## SUBDIVISION REVIEW SHEET

**CASE NO.:** C8-2019-0112.1A

**SUBDIVISION NAME:** Twilight Gardens

Exhibit C: Comment report dated October 13, 2021

**TWILIGHT GARDENS**  
**PLAT OF A 17.991 ACRE TRACT OF LAND**  
**COMPRISED OF A 10.002 ACRE TRACT OF LAND**  
**AND A 7.989 ACRE TRACT OF LAND**

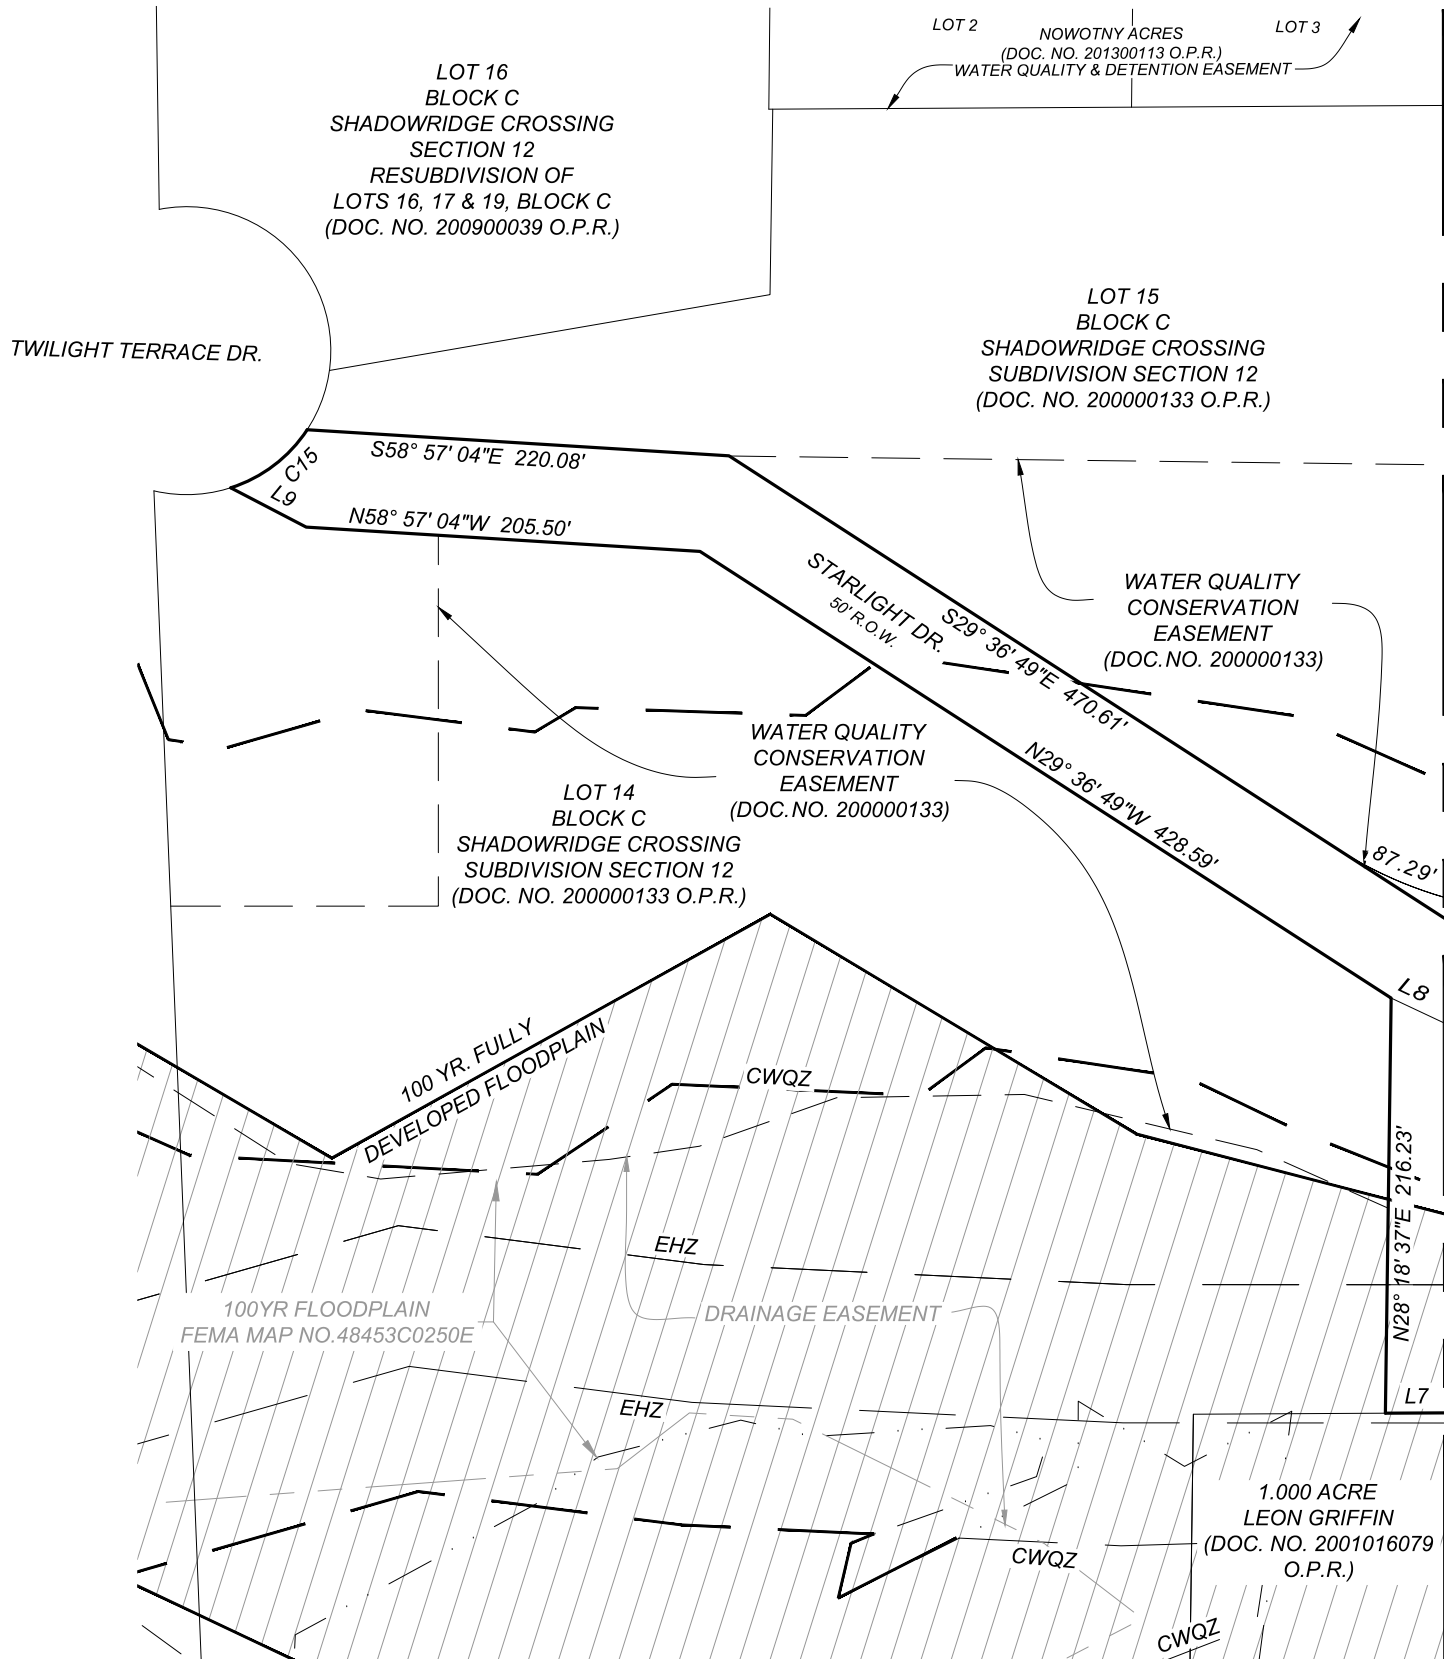
DE4 It looks like the second portion of note 15 can be removed.

DE5 Note 18 can be removed as note 15 addresses no adverse impact.

DE6 For note 21, the lot size summary table impervious cover can be put into the water quality section of the engineering report and can be removed from the plat as these are assumptions and not specific restriction required on the plat.

EV 2 Remove the specific reference to Land Development Code sections shown in plat notes #13 regarding access to drainage easements, #15 regarding submittal of drainage plans to the City, and #16 regarding obstructions in the drainage easement. A subdivision final plat note should only reference the Land Development Code in general. [[LDC 25-1, Article 4]

SR 21. If fiscal is not required to be posted, add the following note and delete Note 12: 25-1-83, 30-1-113

Replace note 6 with the following note:

WQ1 Remove note 5 or modify as this reference is outdated.

THE WATER AND WASTEWATER UTILITY SYSTEM SERVING THIS SUBDIVISION MUST BE IN ACCORDANCE WITH THE CITY OF AUSTIN UTILITY DESIGN CRITERIA. THE WATER AND WASTEWATER UTILITY PLAN MUST BE REVIEWED AND APPROVED BY AUSTIN WATER. ALL WATER AND WASTEWATER CONSTRUCTION MUST BE INSPECTED BY THE CITY OF AUSTIN. THE LANDOWNER MUST PAY THE CITY INSPECTION FEE WITH THE UTILITY CONSTRUCTION
